City of Issaquah
Major Development Review Team (MDRT)
Administrative Site Development Permit

NOTICE OF DECISION

SUBJECT: Administrative Site Development Permit for Block 23, Issaquah Highlands

Number: ASDP11-00006

1. Site plan, Sept 9, 2011, Sht. L1.01
2. Rear drive aisle dimensions and clear zone
3. Entry drives/drive aisle radii

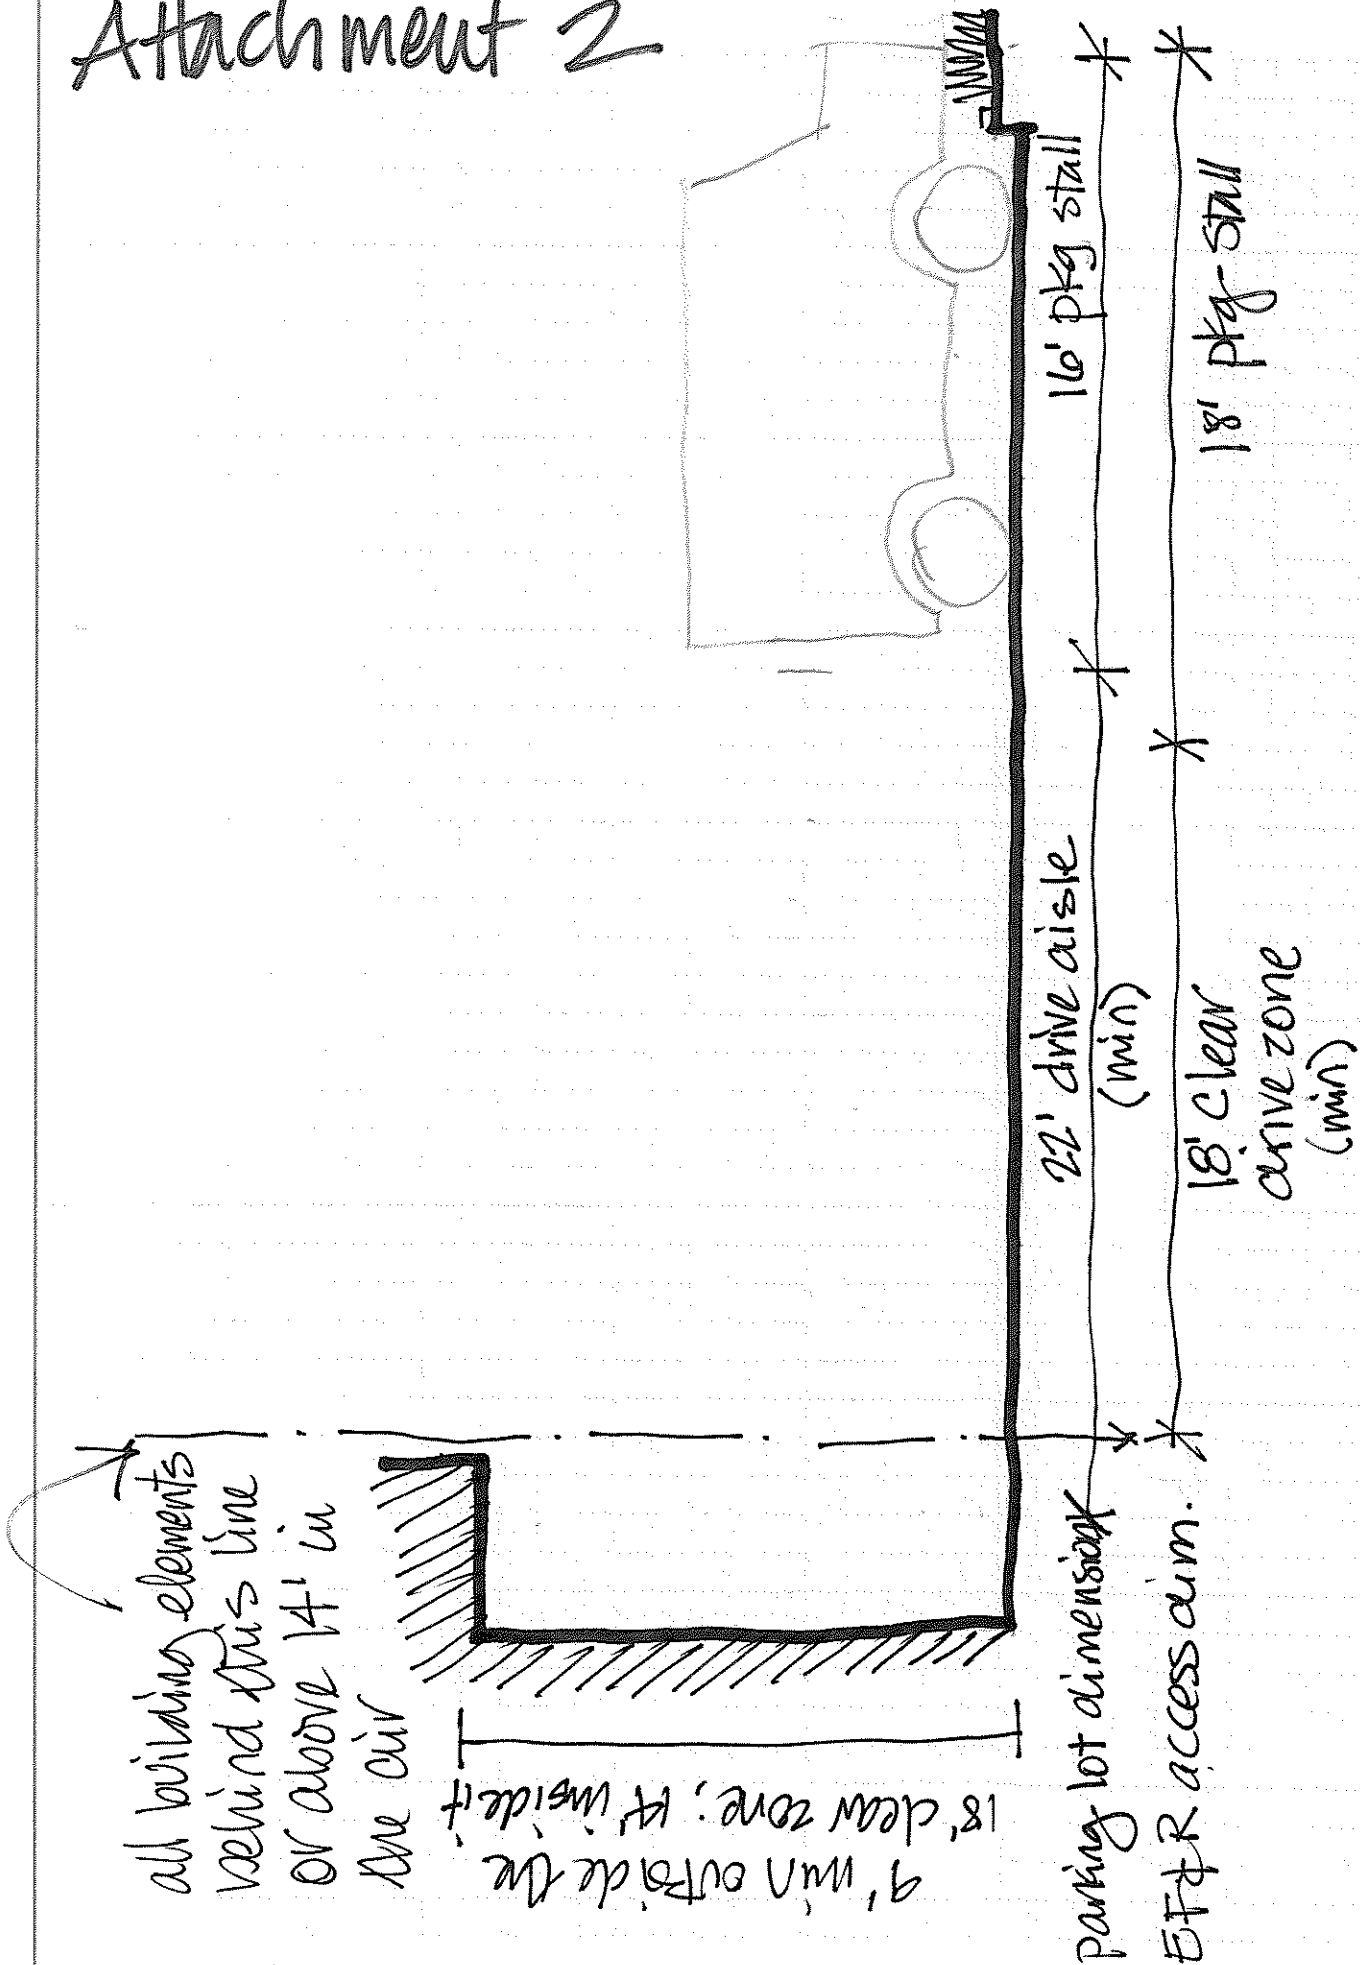
33. Provide smaller radius turns where the entry drives transition to the drive aisles. Use rolled curb and scored or stamped concrete to accommodate fire and garbage truck turning movements. See Attachment 3.

34. The building overhangs, balconies, etc... and the parking lot dimensions must comply with Attachment 2 to ensure Eastside Fire and Rescue have sufficient access to the rear of the building.
